SEISMIC RISK ANALYSIS FOR  
GENERAL ELECTRIC PLUTONIUM FACILITY  
PLEASANTON, CALIFORNIA  
PART I

Submitted to:  
LAWRENCE LIVERMORE LABORATORY  
P.O. Box 808  
Livermore, California 94550

July 31, 1978

ERRATA SHEET

FIGURE 5-1  
SEISMIC SOURCE REGIONS  
USED IN THE ANALYSIS

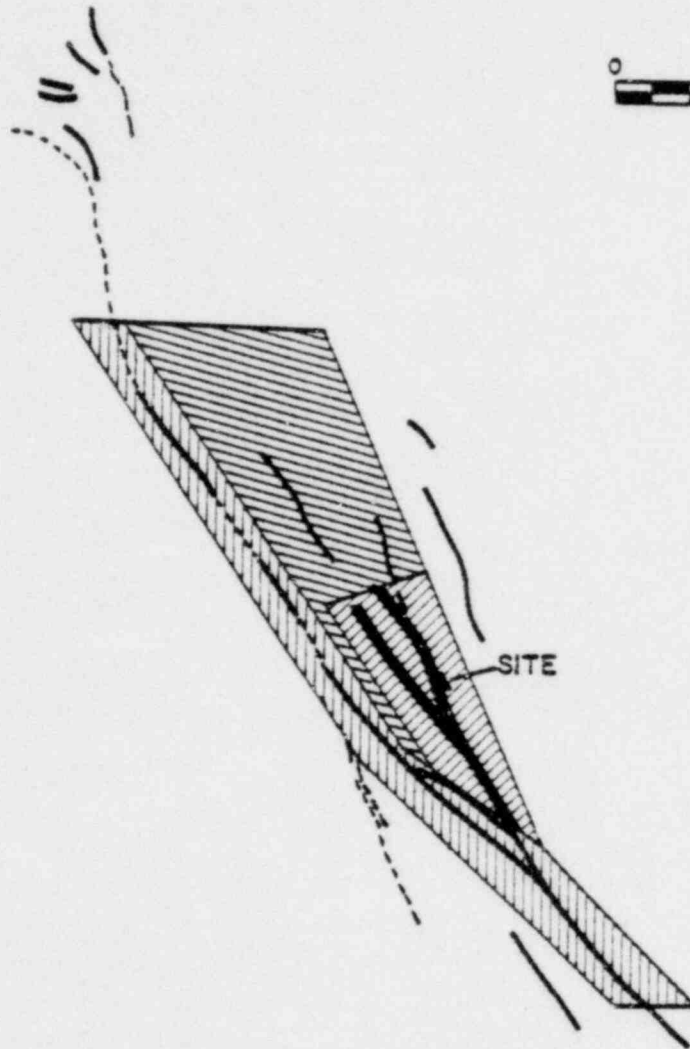
Figure 5-1, Legend

Calaveras is mis-spelled twice as "Calavaras".

FIGURE 5-3

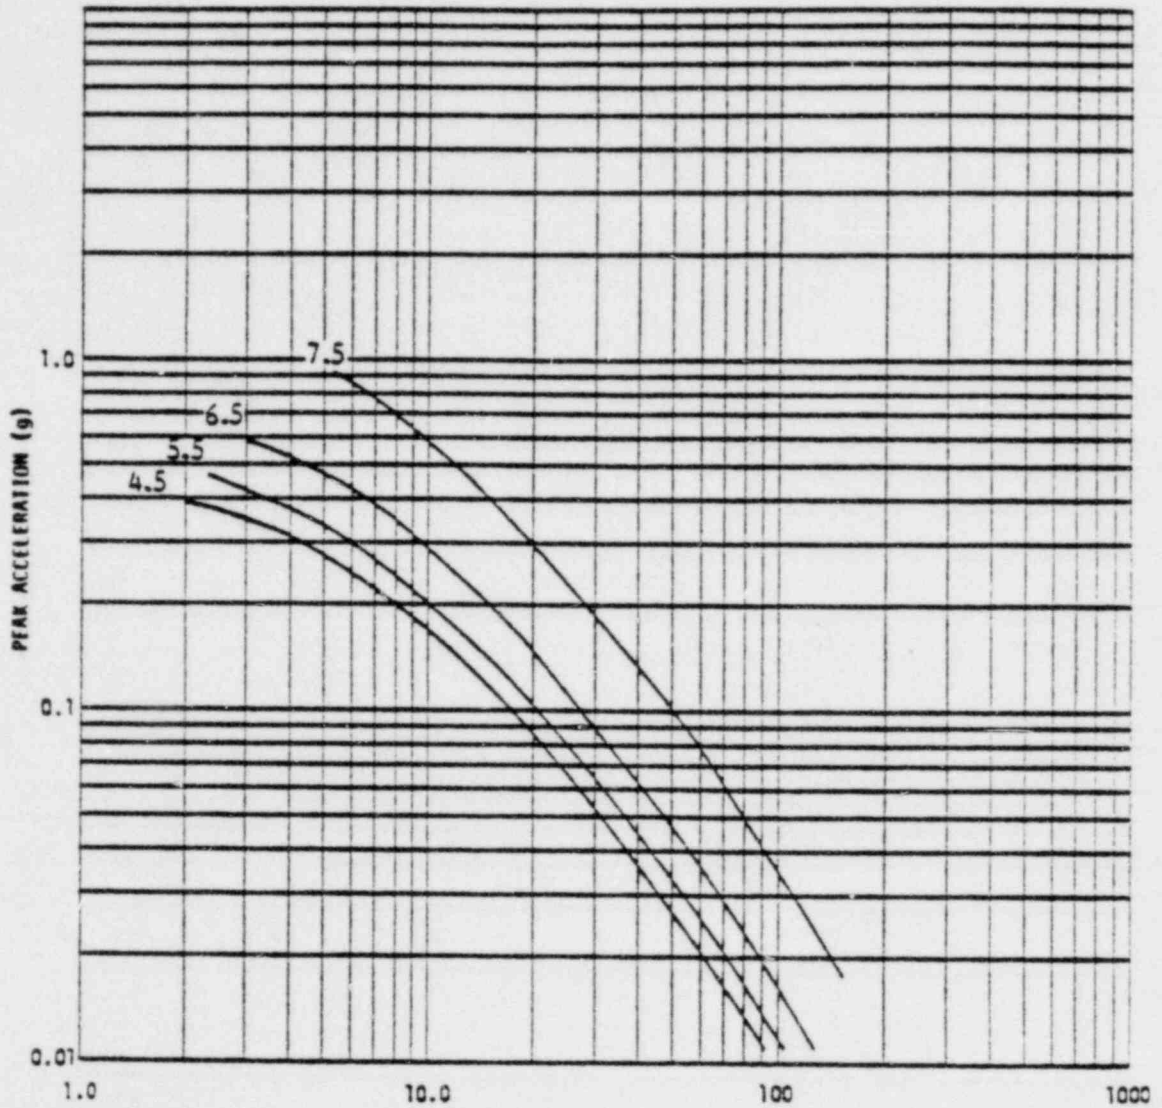
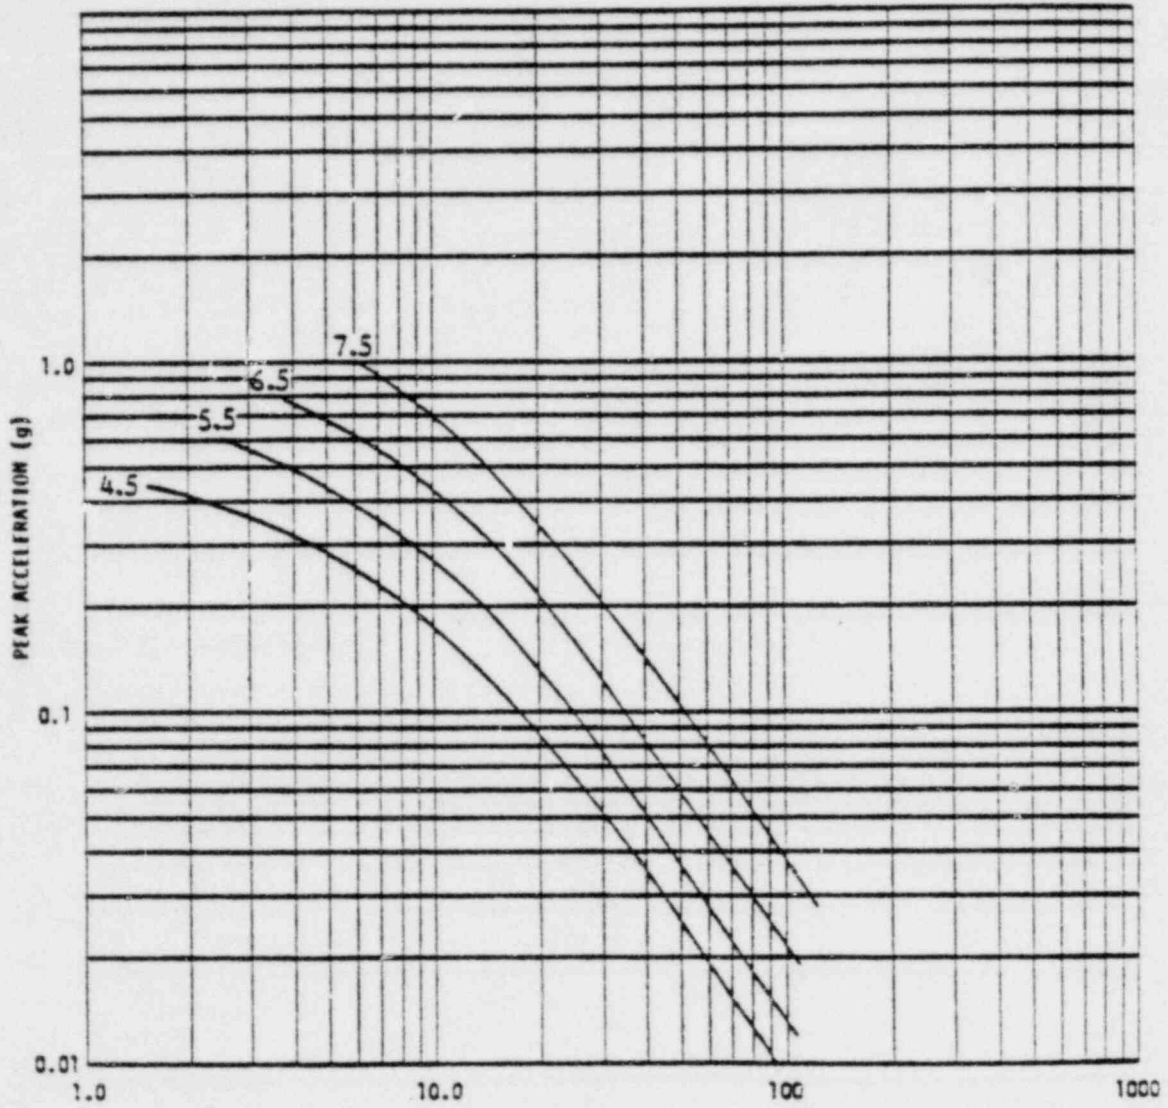
Figures 5-3 and 5-4,

ordinate scale should be labelled

r Kilometers
